UN Regulation No. 51 (Noise of M and N Categories of Vehicles)

Proposal for a Supplement to the 03 series of amendments to UN Regulation No. 51

Submitted by the experts from the International Organization of Motor Vehicle Manufacturers*

39. Graph 2: Impact of Sound emission limits based on the slope assessment as proposed by the amendments provided in this supplement to UN Regulation No. 51 on EVs with ESES

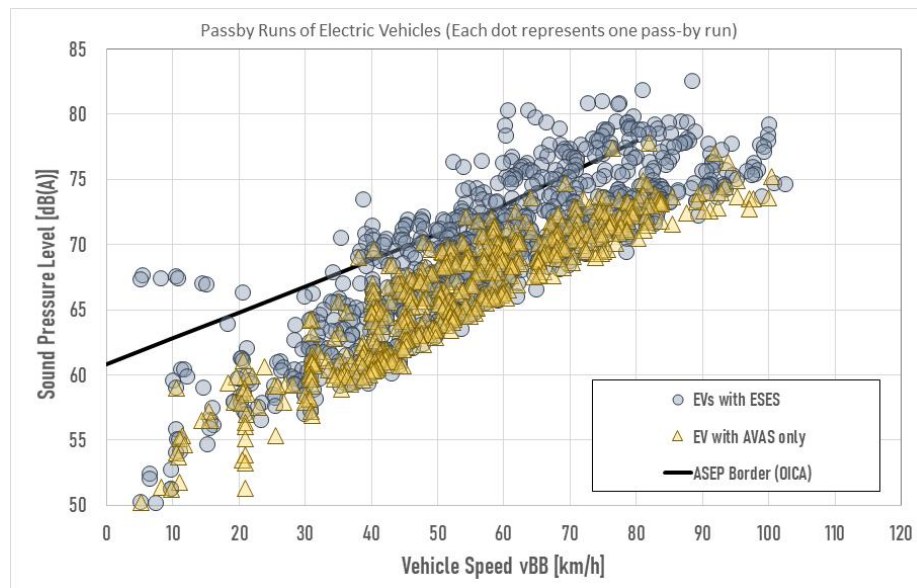
40. Explanation of the graph 2:

- The proposed limit (black line) is related to accelerated conditions of ASEP, which are the worst conditions for urban sound emission (same as in Graph 1).
- The green and red dots in the graph 2 represent different driving conditions of different vehicles equipped with an ESES including AVAS. The green dots show pass-by test runs of EVs meeting the proposed ASEP-requirements of this amendment, while the red dots show pass-by-tests of EVs failing the same requirements. The limit curve is designed in a way that vehicles equipped with an AVAS-only just fulfil the sound emission requirements.

34. Graph 1: Sound emission limits for EVs based on the slope assessment as proposed by the amendments provided in this supplement to UN Regulation No. 51

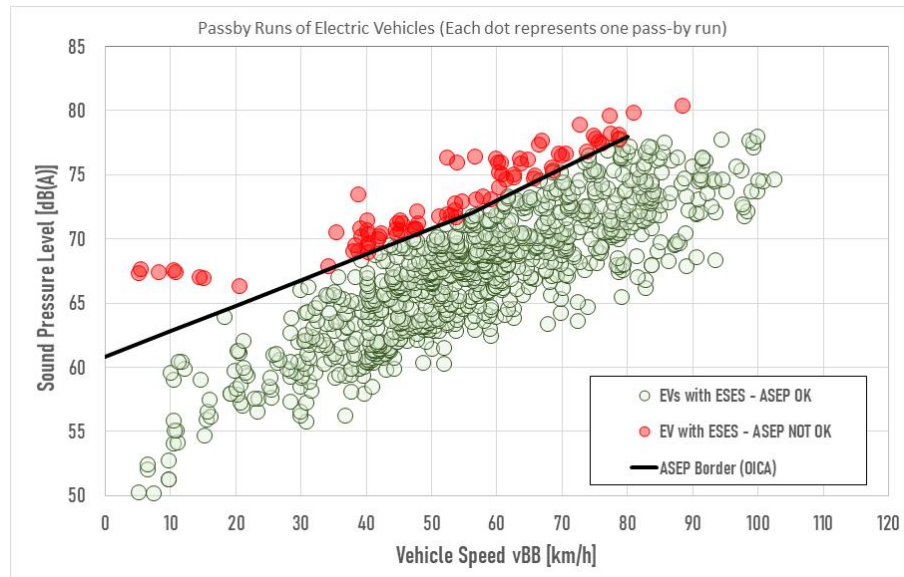
35. Explanation of graph 1:

- The proposed limit (black line) is related to accelerated conditions of ASEP, which are the worst conditions for urban sound emission.
- The crossing point at 0 km/h matches the maximum sound limits for stand-still condition in UN Regulation No. 138, 02 series of amendments (corrected from 2.0 m to 7.5 m due to the different methods in UN Regulation No. 138 and UN Regulation No. 51). As UN Regulation No. 51 does not provide a suitable measurement method for measuring sound in stand still condition, provisions on stationary sound cannot be included.

- The blue dots and yellow triangles in the graph 1 represent different driving conditions of different vehicles. The yellow triangles show pass-by test runs of EVs only equipped with an AVAS, while the blue dots show pass-by-tests of EVs equipped with ESES including AVAS. The limit curve is designed in a way that vehicles equipped with an AVAS-only just fulfil the sound emission requirements.

42. Graph 3: Example for a vehicle where the measured sound under cruise condition is closest to the ASEP limit curve.

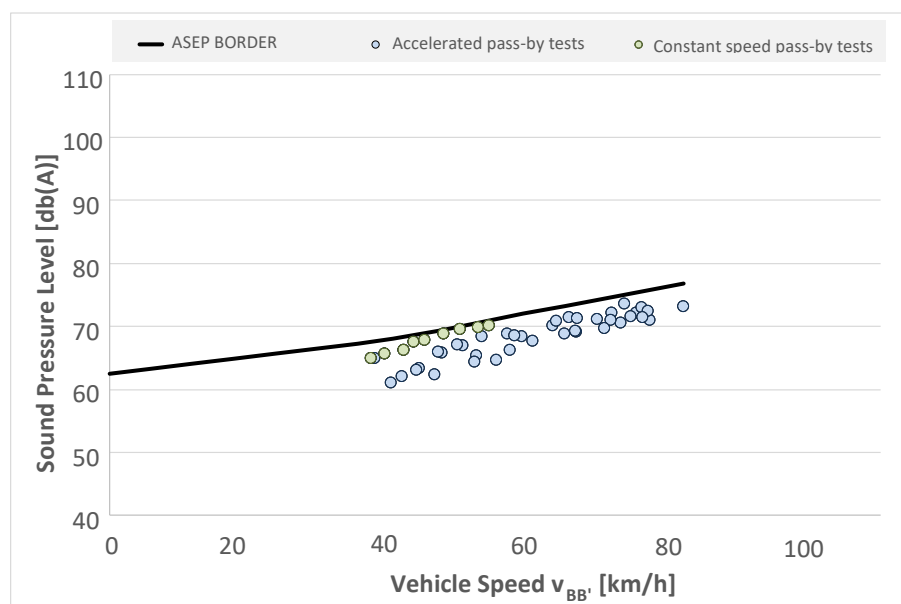
41. In addition, some EVs show that the cruise test result of Annex 3 is higher than the acceleration test result of Annex 3, which adds further uncertainty, as the anchor point based on the accelerated condition of Annex 3 is not the worst case from Annex 3, as shown in graph 3. Therefore, it is proposed to cover EVs with specified criteria under the provisions for non-locked automatic transmission.

43. Explanation of graph 3:

- The proposed limit (black line) is related to accelerated conditions of ASEP, which are usually the worst conditions for urban sound emission (same as in Graph 1).
- The blue and green dots in the graph 3 represent different driving conditions of one vehicle. The blue dots show pass-by test runs of this EVs accelerating, while the green dots show pass-by-tests of EVs cruising at constant speeds. This vehicle nearly fails the sound emission requirements in regard to the constant speed tests (green dots).
